ARCHITECTURAL REVIEW BOARD MEETING
CITY HALL, 385 SOUTH GOLIAD STREET, ROCKWALL, TEXAS
MARCH 25, 2025 IN THE CITY COUNCIL CONFERENCE ROOM AT 5:00 PM

PROJECT COMMENTS

PROJECT NUMBER: SP2025-011
PROJECT NAME: Site Plan for 2301 SH 276
SITE ADDRESS/LOCATIONS: 2301 STATE HIGHWAY 276

SHEET
SP-1

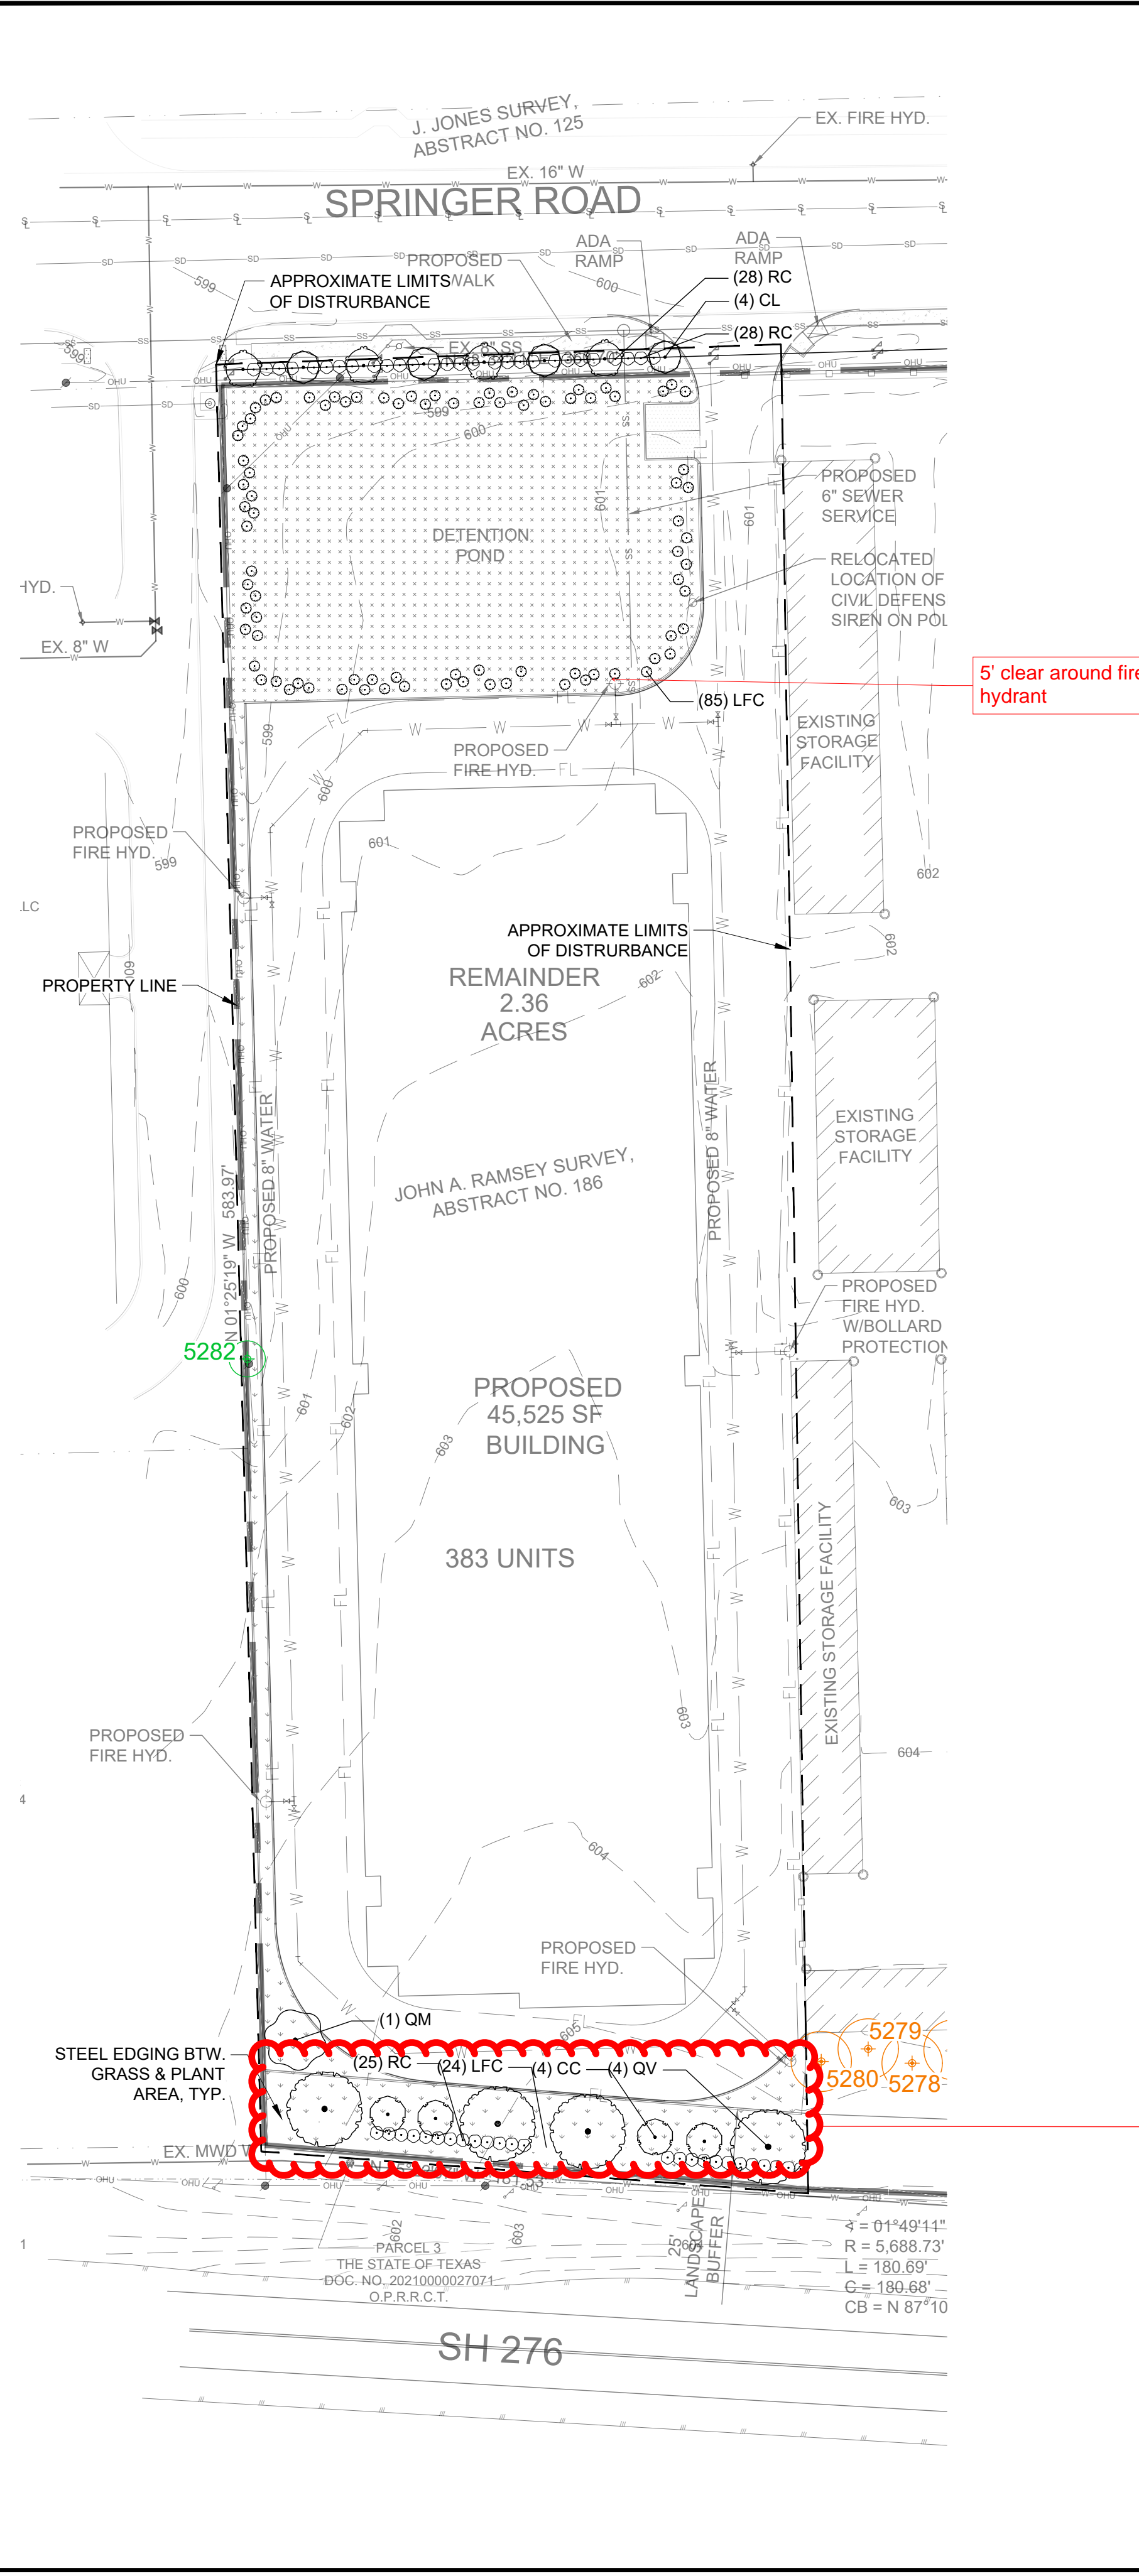
M.7 Site Plan.

- (6) All pad mounted equipment must be shown on the site plan. This equipment must be screened with five (5) gallon evergreen shrubs, which should be shown on the landscape plan. (Subsection 01.05.C, of Article 05, UDC)

- (7) Please provide a note that there shall no above ground storage tanks or outside storage, which includes vehicles. (Subsection 01.05. B, of Article 05, UDC)

- (8) To clarify, are the storage units contained within the building and there shall be no roll up doors? (Subsection 01.05. A, of Article 05, UDC)
- (9) Please clarify if there will be a dumpster. All dumpster enclosures must be 12-feet by 10-feet, and within the overlay district they must be 8-feet in height. If there will be an enclosure, please correct the site plan and provide a dumpster detail to reflect this. In addition, please denote that the brick on the enclosure will match the primary building. (Subsection 01.05.B, of Article 05, UDC)

- (10) No gutters, downspouts, or scuppers shall face a roadway. (Subsection 02.03, of Article 04, UDC)
- (11) Per the Conditional Land Use Standards, the "number of storage units per acre shall not exceed 125, the minimum number of storage units shall be ten (10), and the maximum site area shall be five (5) acres." In this case, you are proposing 704 units. This request will be an Exception that the Planning and Zoning Commission must consider.

12. Verify that this ROW line is the new/proposed TXDOT for the SH 276 widening project
 13. 5' clear around fire hydrant
 14. No trees within 10' of water line along SH 276 and 5' from the 8" water line loop in the fire lane

4 WEST ELEVATION
SCALE: 1/16" = 1'-0"

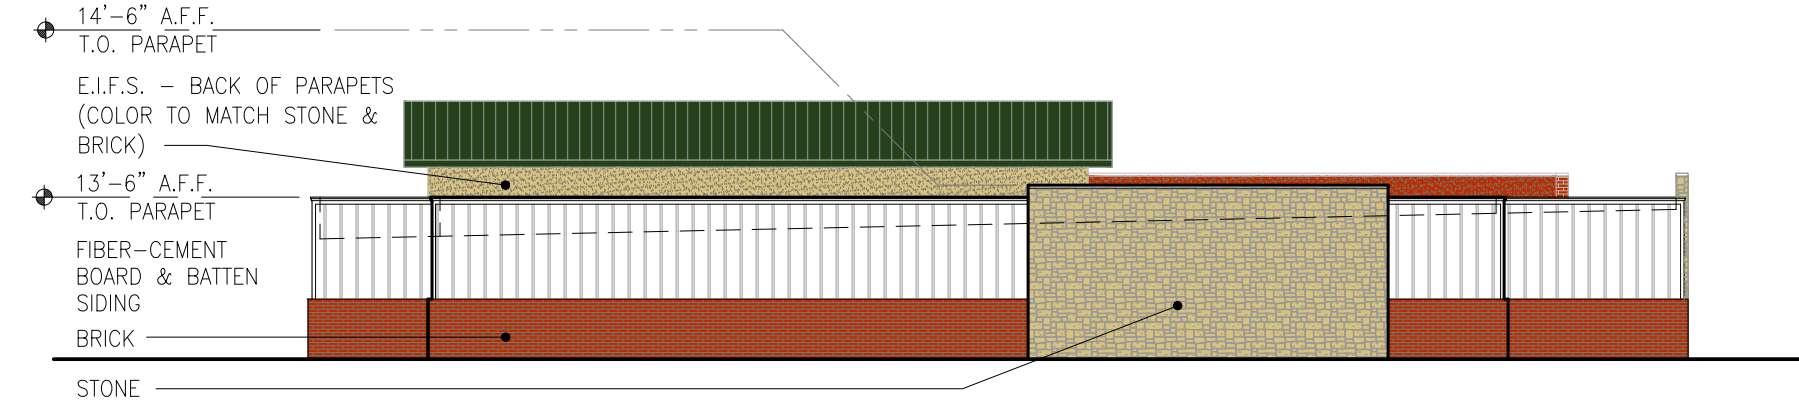
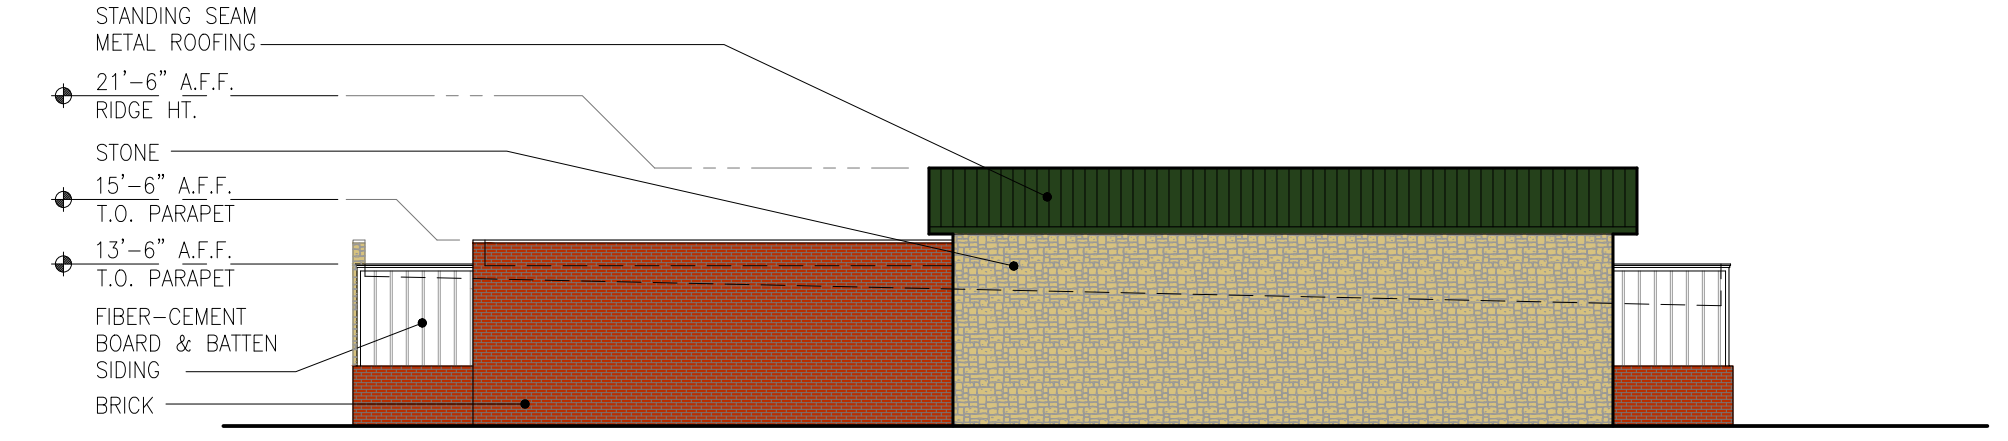
- (3) EIFS is not a permitted building material. Please utilized three (3) part stucco. (Subsection 06.02.C, of Article 05, UDC)
- (4) Please provide a note that the back side of the parapet must be finished in the same material as the external facing façade. In addition, all parapet systems must be enclosed. In this case, it appears that there is no parapet on the back of the building. (Subsection 06.02, of Article 05, UDC)

- (6) The proposed building does not meet the four (4) sided architecture requirements. This requires the same "materials, detailing, articulation and features" on each façade. In this case the primary articulation requirements must be met on each side, and the same architectural detail and features must be provided on each side. (Subsection 06.02, of Article 05, UDC)
